Subject: UniStar Nuclear Energy, NRC Docket No. 52-016
Response to Request for Additional Information for the
Calvert Cliffs Nuclear Power Plant, Unit 3,
RAI No. 253, Seismic System Analysis

**RAI 253 Question 03.07.02-46 for the ESWB and EPGB, and
Questions 03.07.02-49, 03.07.02-50 and 03.07.02-51
Seismic System Analysis**

Calvert Cliffs Nuclear Power Plant Unit 3

Figure 1. Plan View – Basemat of EPGB

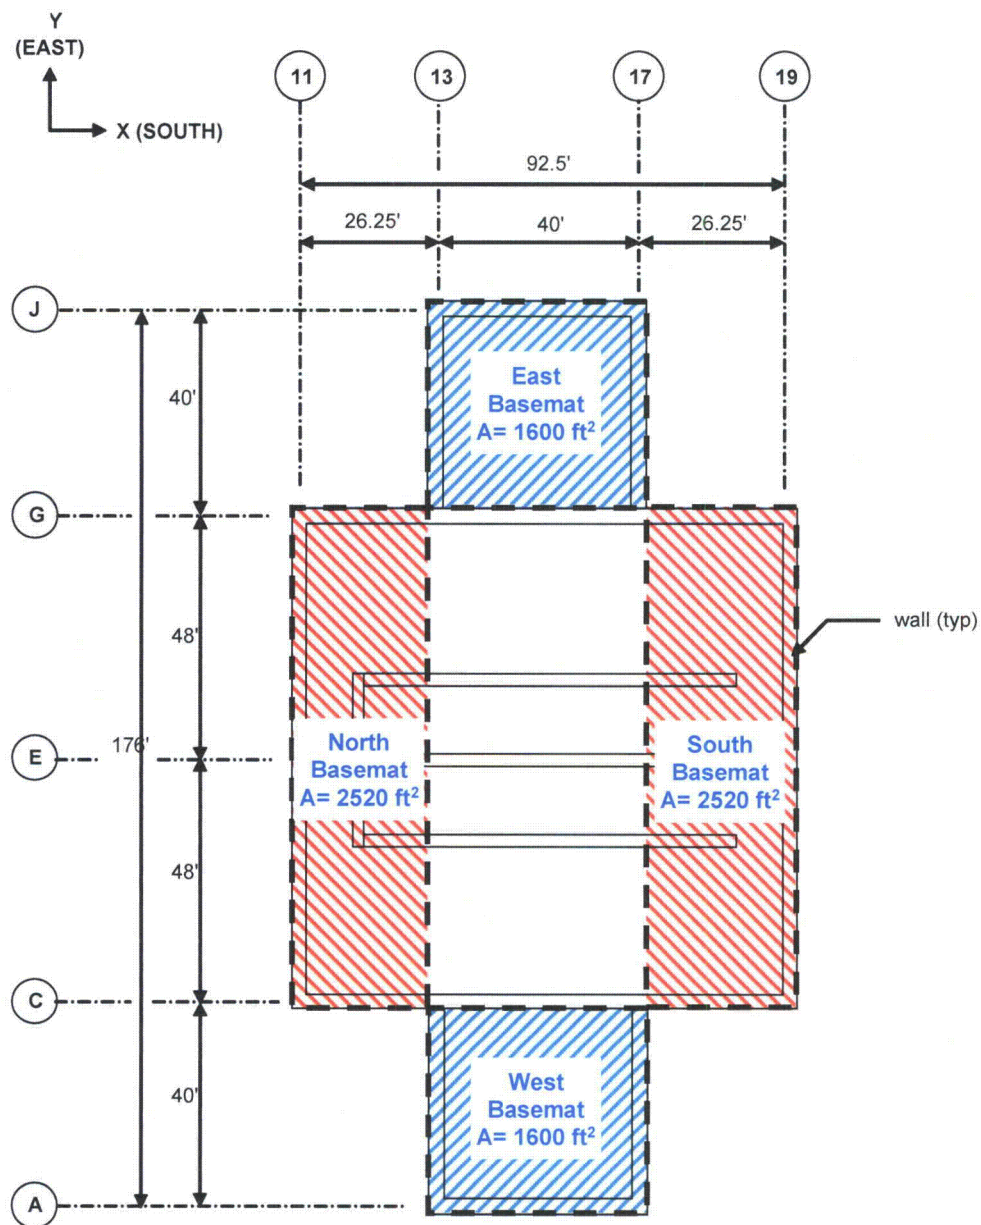
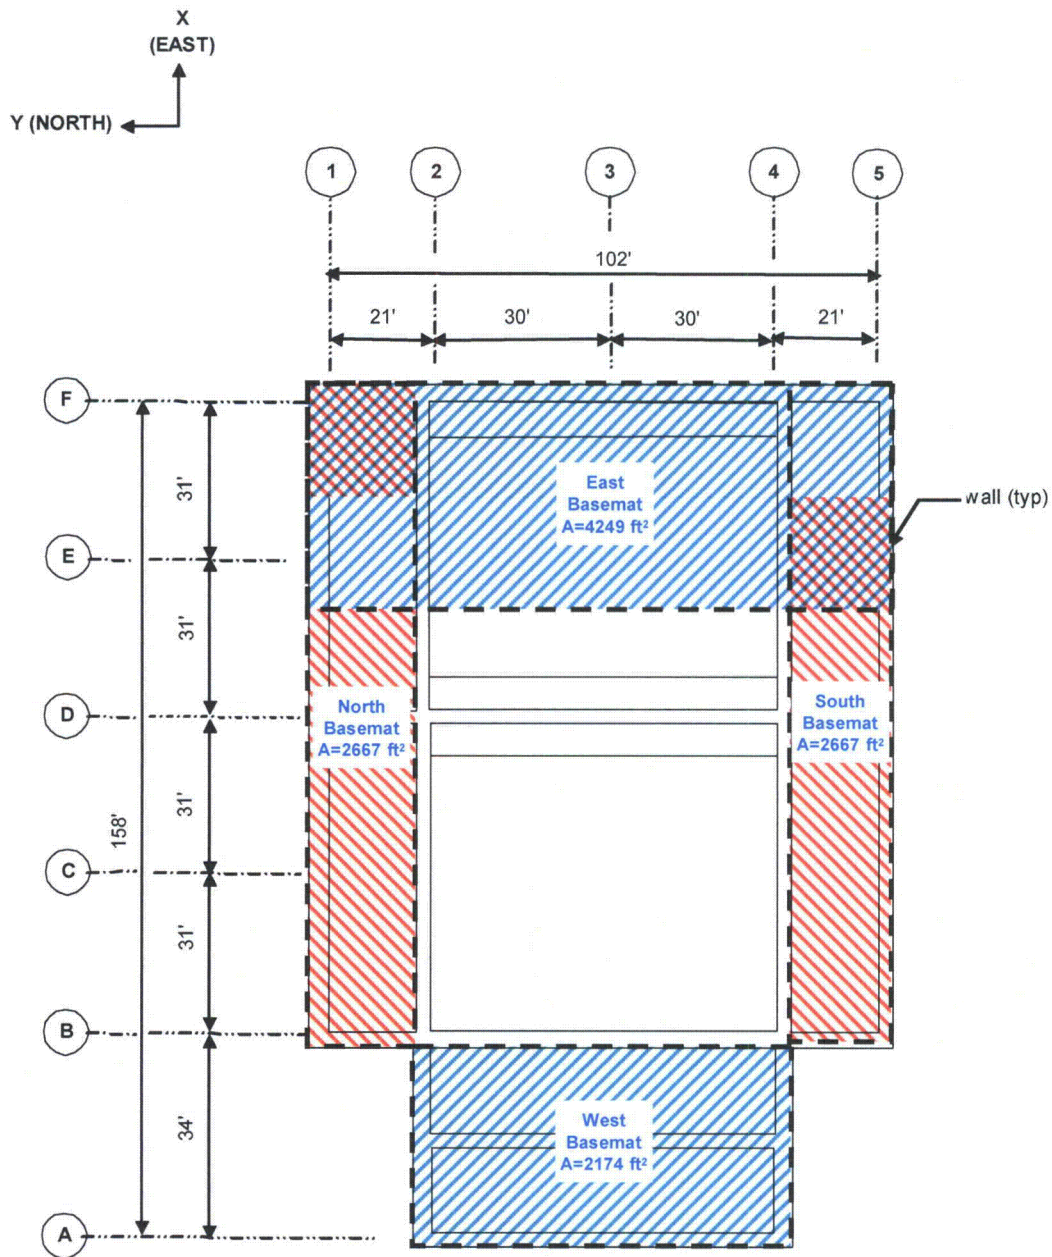
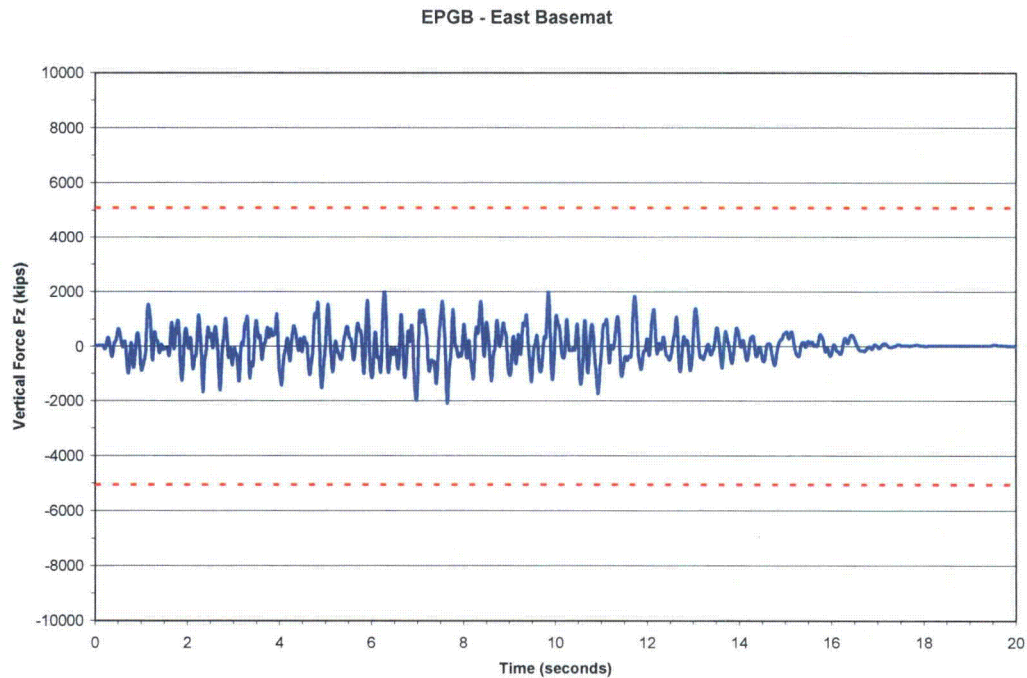
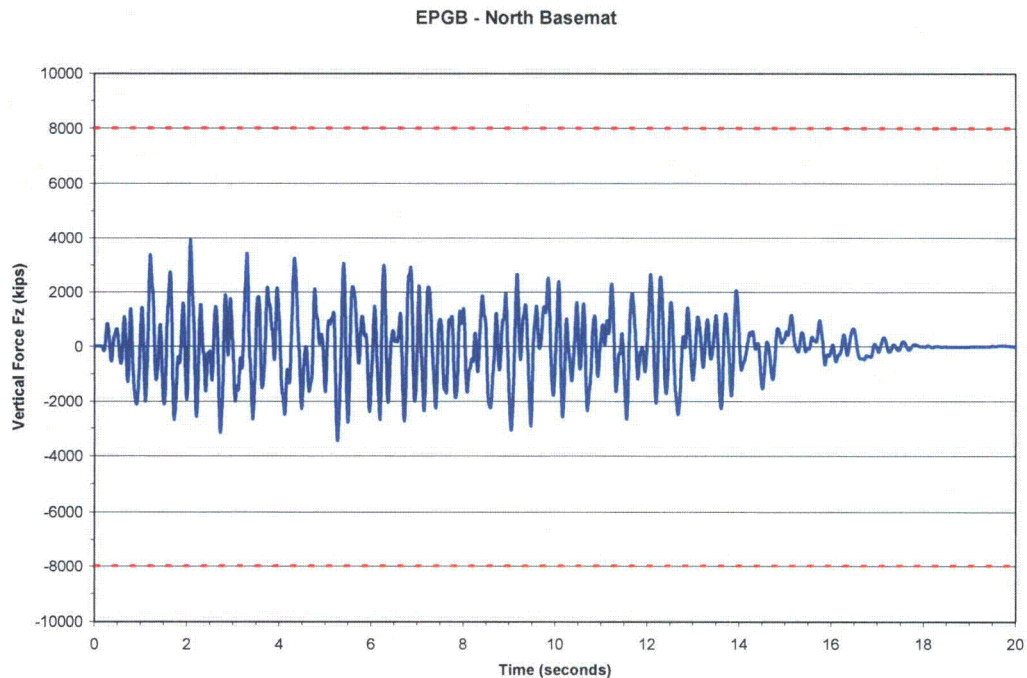
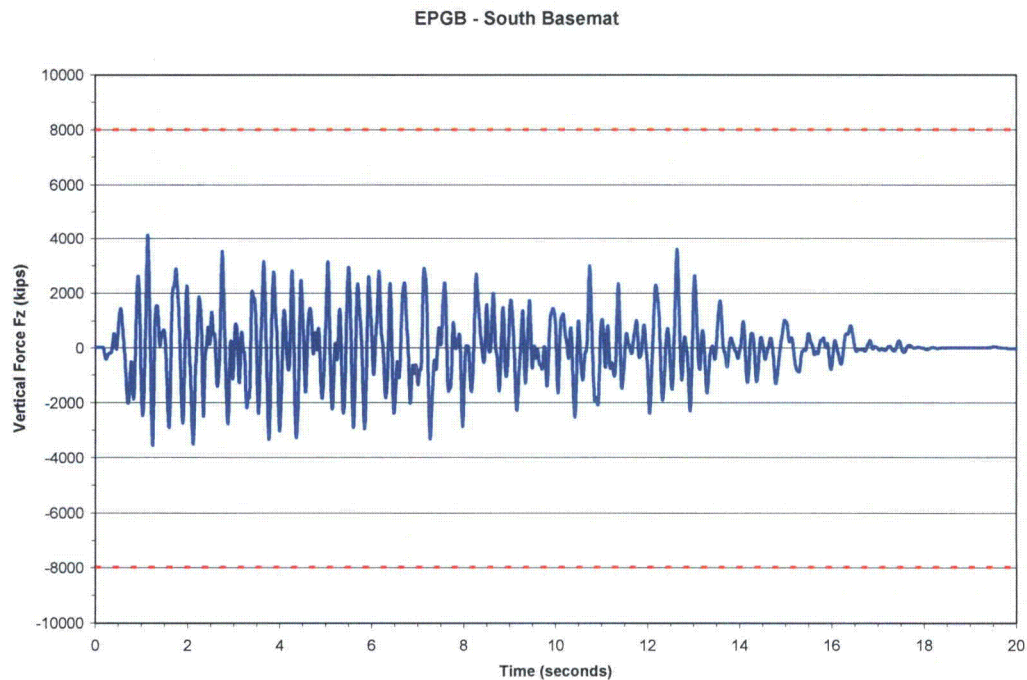
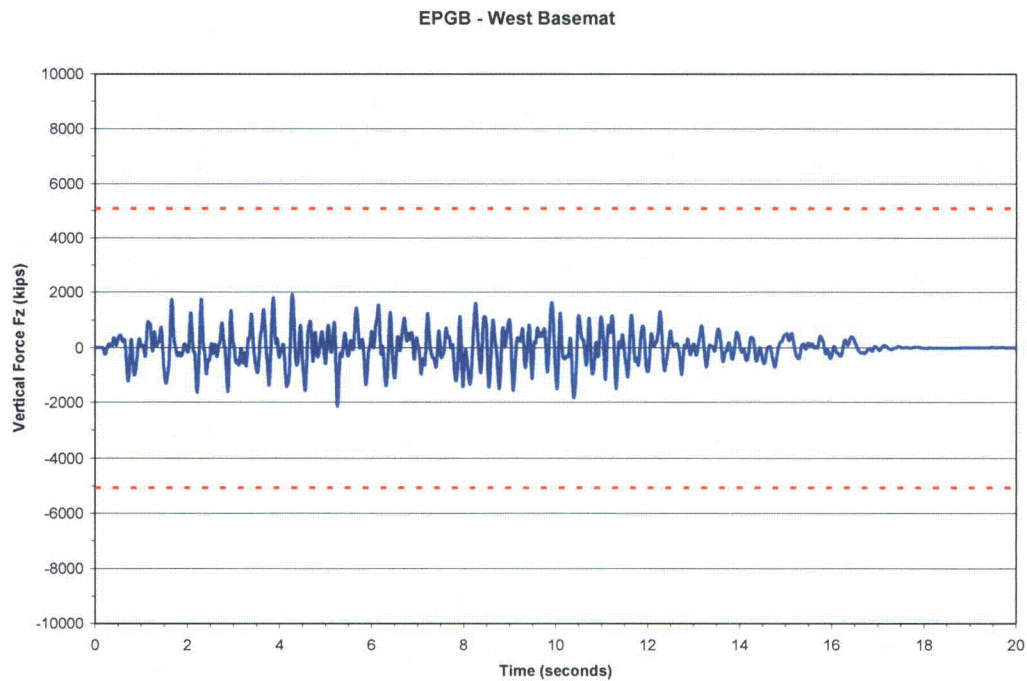
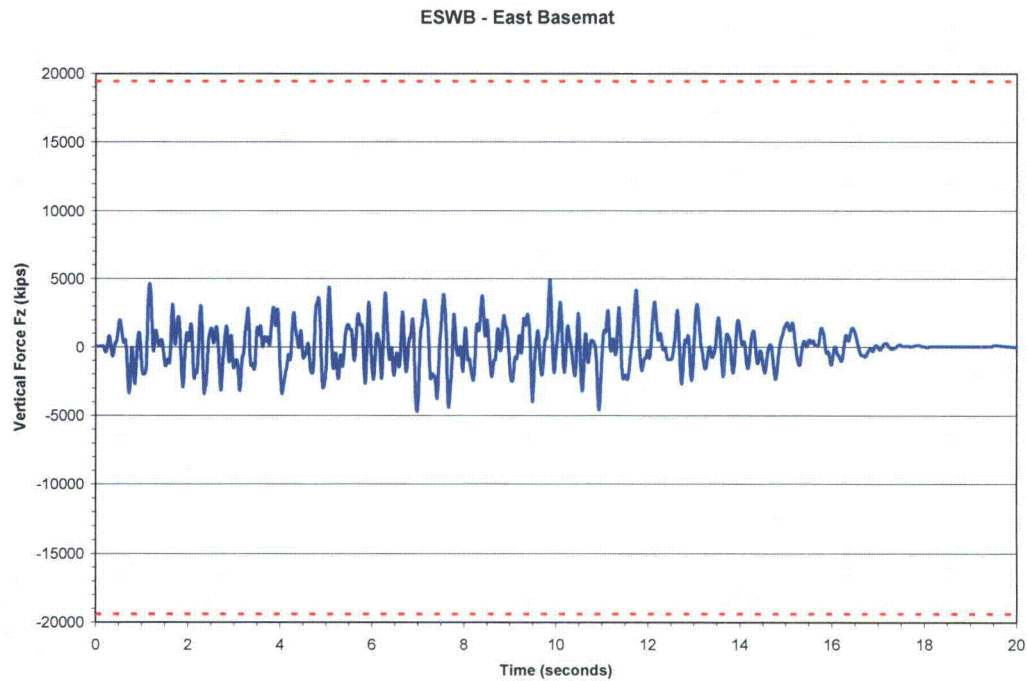
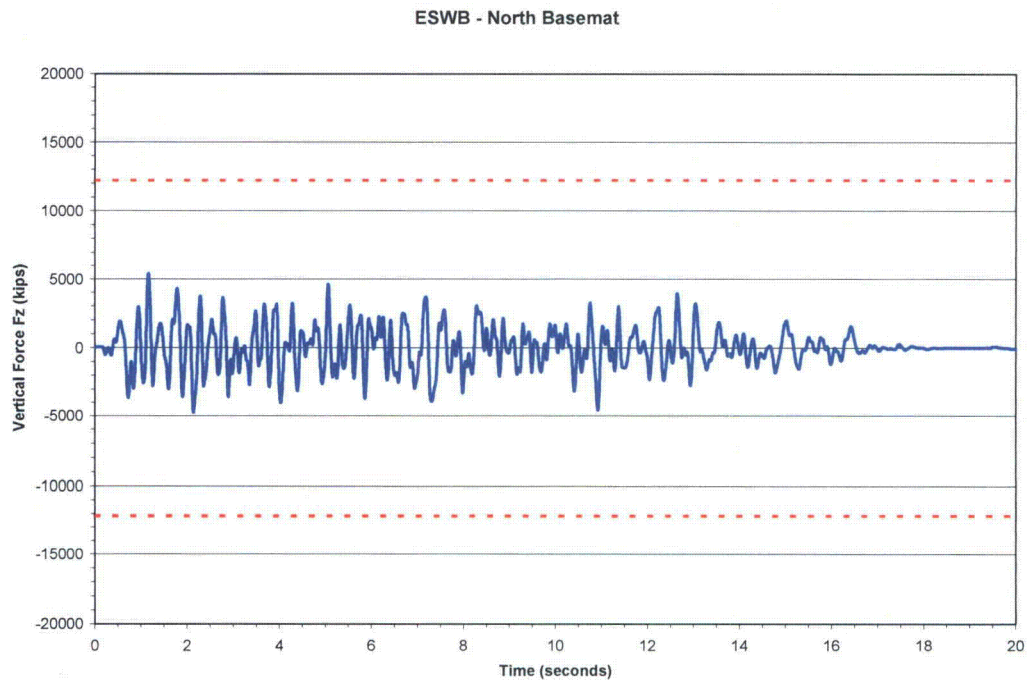
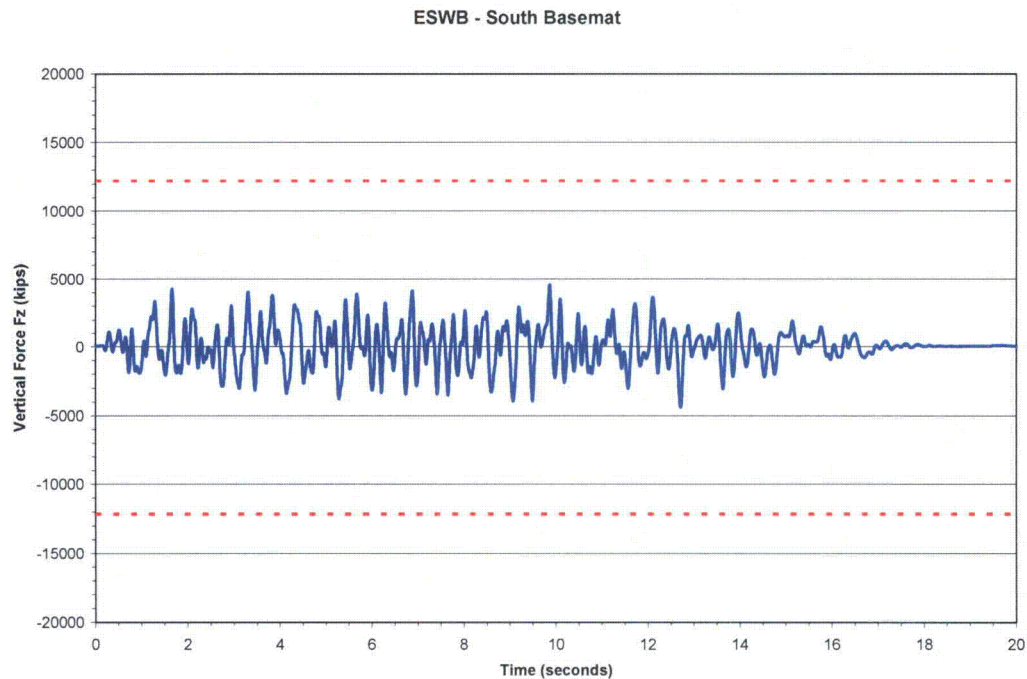
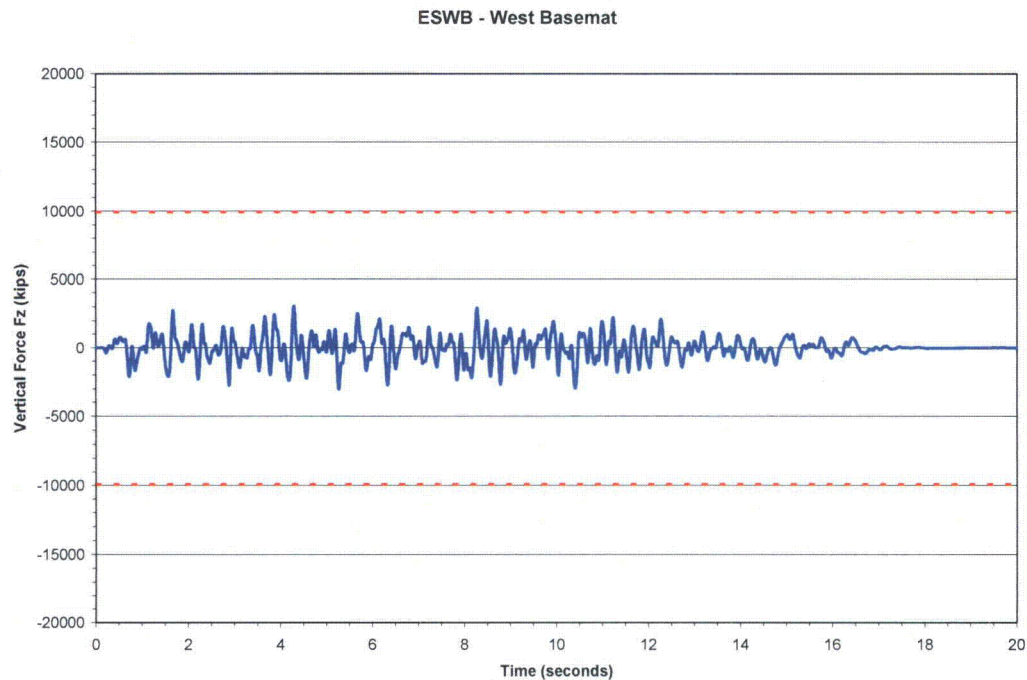
The applicant stated that the results of the SASSI analysis are used for the overturning and sliding calculations of the EPGB, ESWB, CBIS, and UHS EB. The applicant is requested to describe whether or not during the seismic response of these structures there exists a vertical tensile force between the bottom of the basemat and the supporting subgrade. Since this would indicate an uplift of the mat where such a force is indicated, the applicant is requested to describe the effect this has on the results of the overturning and sliding analysis and whether the results of these analyses can be considered as valid if such an effect exists.

For both the EPGB and the ESWB, net vertical seismic spring forces at 4 zones (east, west, north, and south) of the basemat, due to seismic input motions in 3 global directions, are calculated for the controlling upper bound soil case and compared with the tributary weight of each zone. The four zones of the EPGB basemat and ESWB basemat are shown in Figure 1 and Figure 2, respectively. The net spring force (time history) at each zone is calculated by (1) algebraic summation of each vertical spring force time history due to seismic input in NS, EW, and Vertical directions, and then (2) algebraic summation of the above combined spring force time histories of all of the nodes within each zone.

These net spring force time histories for the various zones are plotted with the tributary weight (labeled as uplift capacity) of each zone in Figure 3 through Figure 6 for the EPGB and in Figure 7 through Figure 10 for the ESWB. The comparisons in these figures show that the total vertical seismic spring forces within each zone are less than the tributary weight for each zone. Therefore, there is no separation between the basemat and the soil below it, there is no uplift for these two SSI models, and there is no impact to the sliding and overturning evaluations in the calculations.

There are two ESWB SSI models, the high water level (HWL) and the low water level (LWL) models where the water stored inside the building structure is at the maximum and minimum levels. For the above evaluation, HWL is conservatively used to calculate the seismic spring forces since that will produce maximum seismic demand, and LWL is conservatively used to calculate the uplift capacities (which is the static weight of the building) since that will produce minimum capacity.
